IN THE MATTER OF Applications by the Central
Plains Water Trust and
Central Plains Water Ltd. to
Take and Use Water for
Irrigation in the Central
Plains area.

Section 42A Officer's Report

Supplementary Report of Howard Raymond Williams

Figure 1: Modelled and monitored flows for the Selwyn River at Coes Ford (figure 7-10 copied from Canterbury Model 2 report).

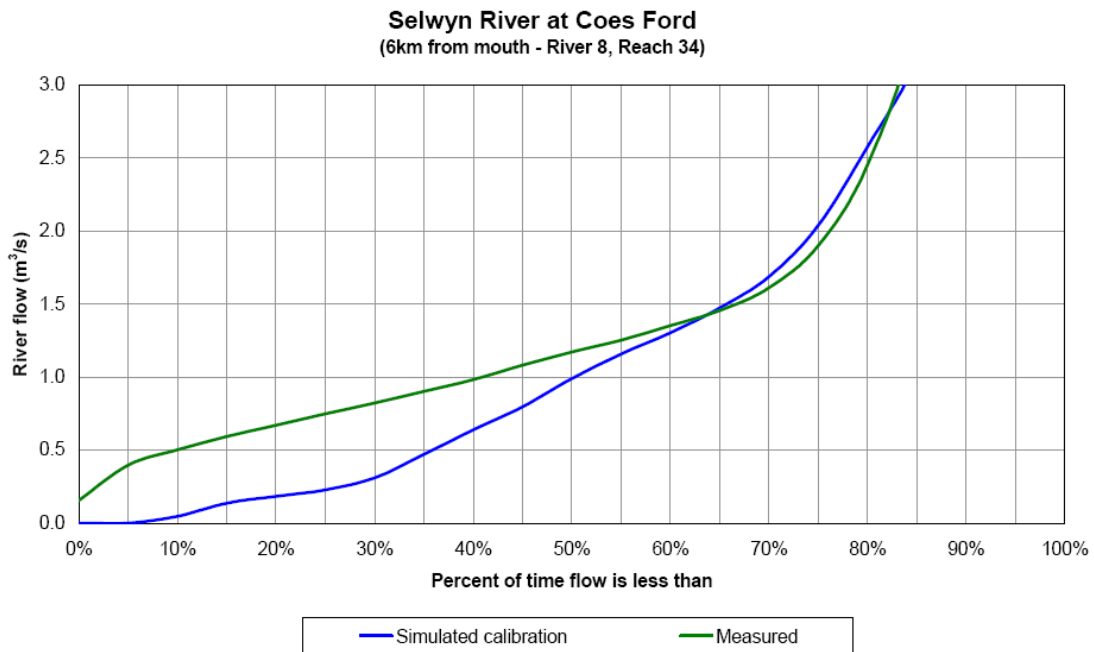
10. In relation to Mr Weir’s evidence in chief, paragraph 82 et seq. on Cumulative Stream Flows, I make the following observation: Figure 7-10 in the Canterbury Model 2 report (Figure 1) shows that Selwyn River flows at Coes Ford are simulated very differently from monitored flows, especially at low flows.

11. I am concerned that these plots have not been included in Mr Weir’s evidence in chief for they could provide a useful means to illustrate the accuracy of the model in predicting surface flows. In the plot shown above (Figure 1), the median flow is underestimated by 20%, and the low flows by as much as several hundred percent. I understand that Mr Weir modified the model for his January 2008 evidence in chief, but these plots do not appear in that revised document.

Figure 2: Flow monitoring and stage height record for Selwyn River at Coes Ford

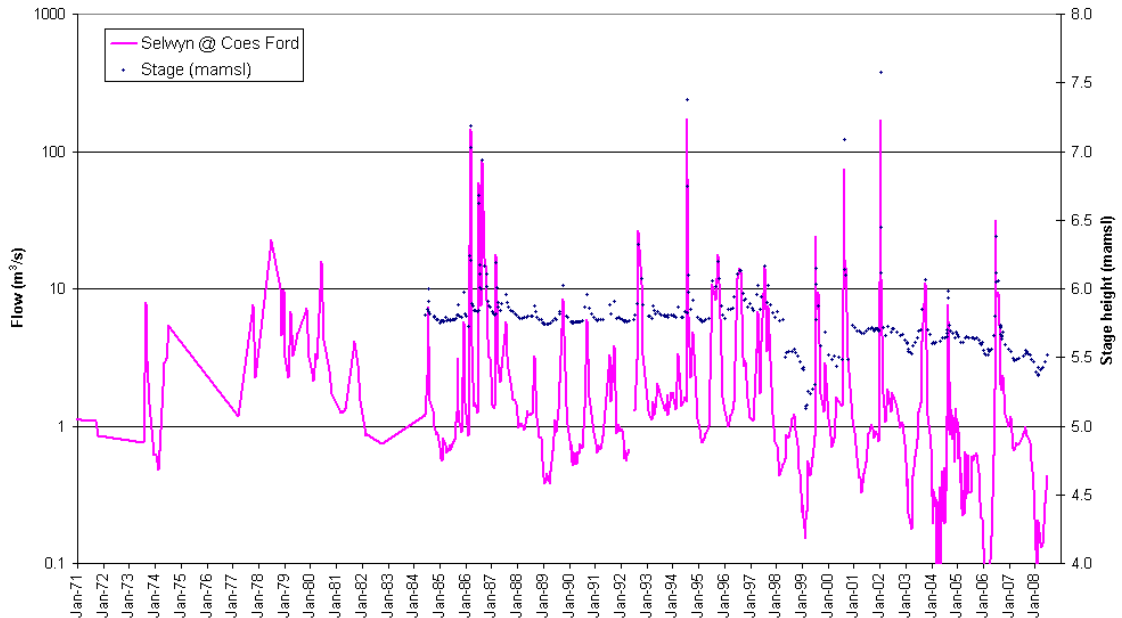
35. Note in Figure 2 that there is a generally declining trend in both stage and flow, especially over the last decade.

Figure 3: Flow monitoring for the LII River at Pannetts Road

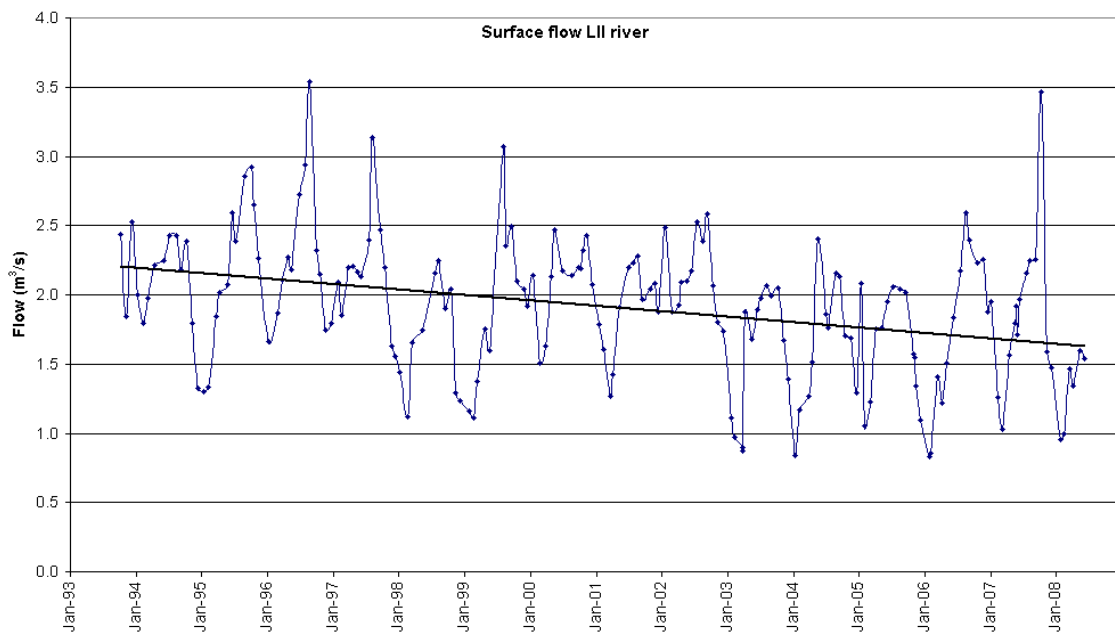
36. In Figure 3, the monitored flow in the LII river is shown, as measured at ?? Road. Note also that the flows, and especially the lowest measured flows in each year of the record for this river have also declined over the last decade.

Figure 4: Groundwater level monitoring record for well L36/0142, 5 km up-gradient of Harts Creek in the Rakaia-Selwyn Groundwater Allocation Zone

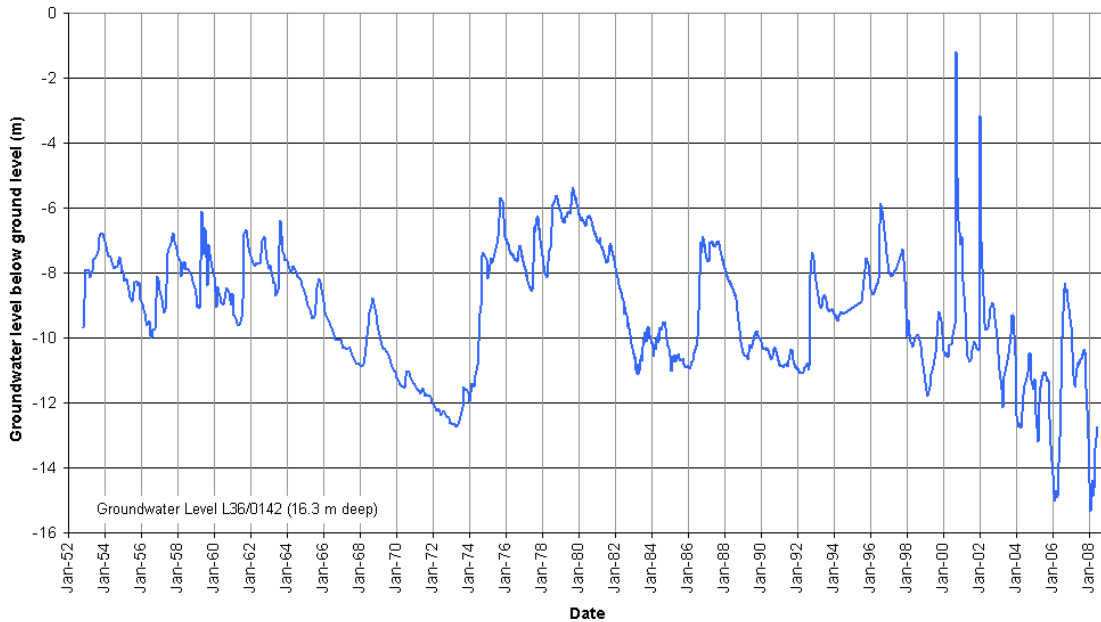
37. The monitoring record for groundwater levels in L36/0142 (Figure 4), illustrates the declining trend in levels, especially over the last decade and the rapid decline in levels even after the wet winter of 2006. The general maximum groundwater level of six metres below ground level is rarely exceeded because the groundwater level is buffered by the discharge from the aquifer at Harts Creek and other spring-fed streams.

Figure 5: Groundwater level monitoring record for well L36/0311, in the Rakaia-Selwyn Groundwater Allocation Zone

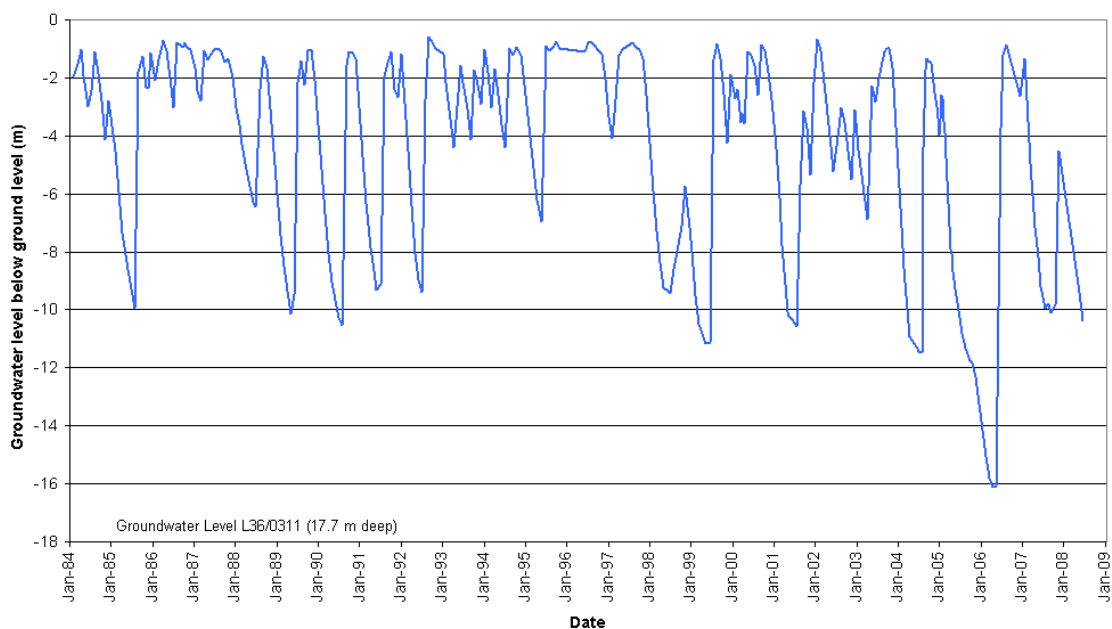
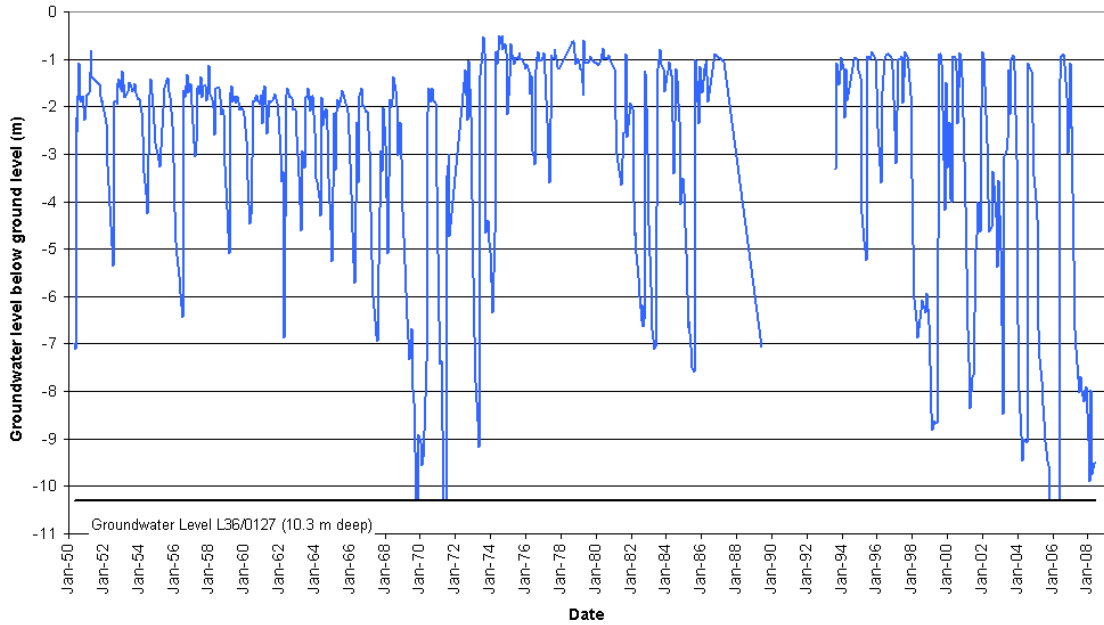
38. In Figures 5 and 6, the monitoring records for wells L36/0311 and L36/0127 shows how the groundwater level generally fails to ascend to greater than a well-defined level. This is because the groundwater discharges from the aquifer rather than producing higher levels. Note, however, how the minimum levels have been decreasing over time, a cumulative effect of climate and abstraction.
39. In Figure 7, the very shallow well M36/3194 also shows the decline in groundwater levels.
